## EASTERN FREEWAY – BURKE TO TRAM ALLIANCE

# Construction Compound Plan – Leonis Avenue and U3 Ramp

Document number: NEL-STH-NSA-5900-EPA-PLN-0007

## Appendix B - Review and Verification Assessment Comment Register

Figure 9: Leonis compound with 1% AEP flood mapping

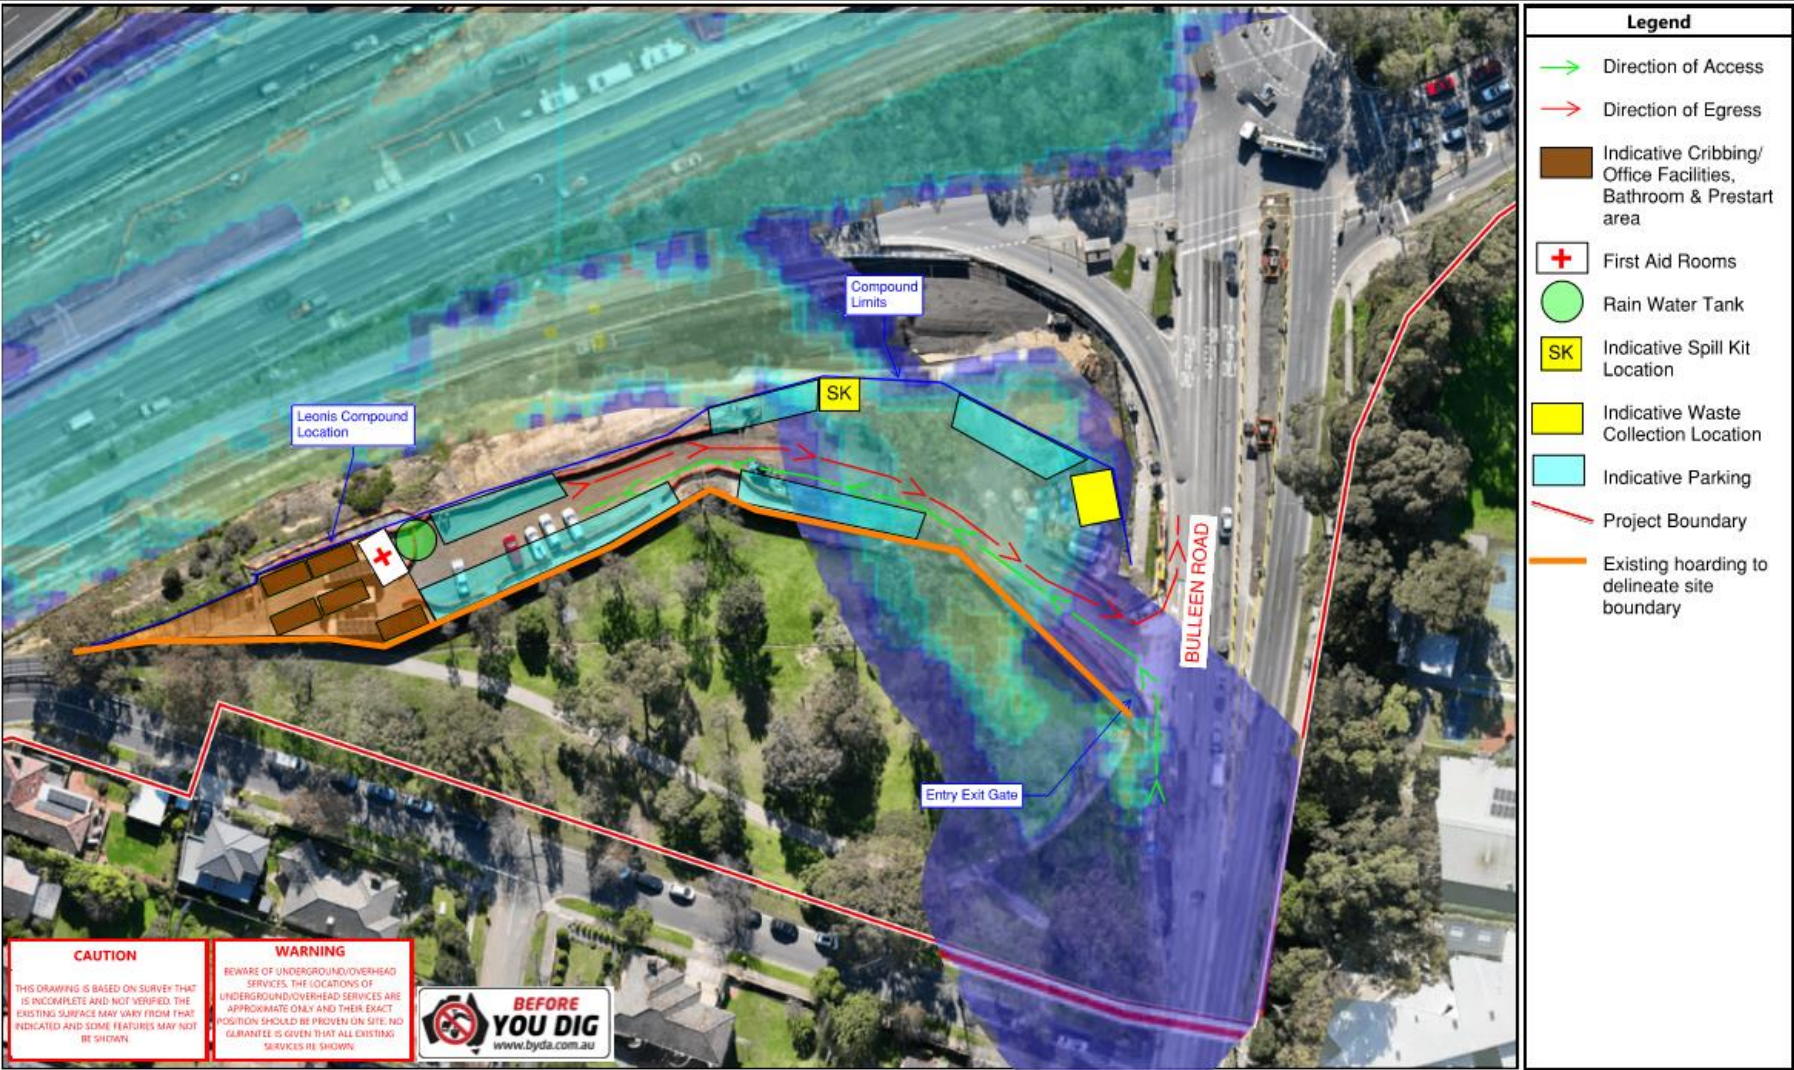
Design Package	Document No	Original Revision	Phase	Item	Related Documents	All Docs related to Design Package	Raised By	Company	Comments	Reference Contract Clause, Standard, Specification or Legislation	Date	Comment Category	Response Category	Reason Code	Comment Status	Closed out
N/A	NEL-STH-HEA-5900-EPA-CRS-0007	D	N/A	09	NEL-STH-ISA-5900-EPA-PLN-0007	N		Freeways EA	EPR SW6 includes the following requirement "...Prior to commencement of relevant works, flood risk should be appropriately assessed using modelling of the design of permanent and temporary works to demonstrate the resultant flood levels and risk profile in accordance with Melbourne Water Standards for Infrastructure Projects in Flood-Prone Areas (2019)...". Clause 4.12.2 (e) includes the following requirement "...Demonstration that the categories of works proposed within the compounds are appropriate having regard to whether the land is flood prone, including any flood modelling where appropriate, to assess any potential for any flood risk". Section 5.1 Flood risk and management of the WGLP states "This compound buildings at Leons Avenue and U3 Ramp are not located within 1 % AEP for flooding therefore flood risk is considered to be not applicable to the compound. The nearest flood affected area is shown for reference in Appendix B." However, the FEA notes that Appendix B indicates that a significant overland flow path exists at the Leons Avenue compound location, directly crossing the compound in which fencing, bunding and/or other associated compound activities have to the potential to impact flood behaviour/risk and has not satisfactorily been addressed in the CCP.	Clause 4, 12 of the North East Link Project Incorporated Document December 2019 (emended September 2023); and EPR SW6	30-05-24	M	N/A	LPE	O	Yes

N/A	NEL-STH-HEA-5900-EPA-CRS-0007	D	N/A	09.01	NEL-STH-ISA-5900-EPA-PLN-0007	N		Eastern Freeway, Burke to Tram Alliance	Permanent buildings at the Leons Ave compound are not located within the 1% AEP flood area. The areas depicted in Figure 9 that within a flow path are "indicative car parking. Heading to the south of the work area (depicted by an orange line) is already in place for the worksite. In the event of a flood, cars would not be in place, spill kits and rubbish bins will be removed. As described in Table 3, the area is partially covered by the 1% AEP flooding area, noting these are caravans and they will be moved throughout the area stated. In the event of imminent flooding, the caravans first aid shed will be removed, therefore will not contribute to any flooding in the area.	Clause 4, 12 of the North East Link Project Incorporated Document December 2019 (emended September 2023); and EPR SW6	07-10-24	M	N/A	LPE	O
